PREDEVELOPMENT PLAN REVIEW COMMENTS

Project Number: PPR2017-00011

Project Address: 1307-1309 & 1355 Lincoln Avenue, Pasadena, CA 91103

Project Description: Review of preliminary plans for demolition of existing buildings and construction of 64 new detached townhomes on a 106,025 square-foot site in the LASP – CL and RS-6 zoning districts.

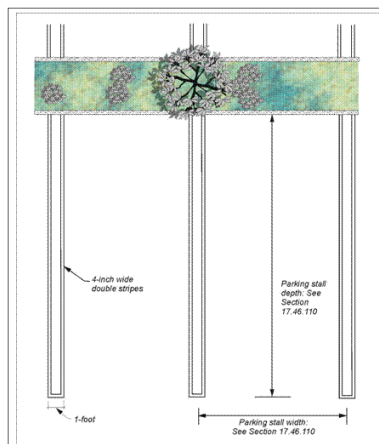
10. **LASP Additional Development Standards (PMC 17.37.070):** The requirements of this section, including provisions set forth for Building Placement, Building Design, Ground Floor Design, and Parking Standards and Driveways, are applicable to the proposed project in the absence of an approved PD plan. Although the plans do not include enough detail to determine compliance with each provision, the project as proposed appears not to be in

compliance with provisions specific to incorporation of windows, façade plane modulation, and ground floor design.
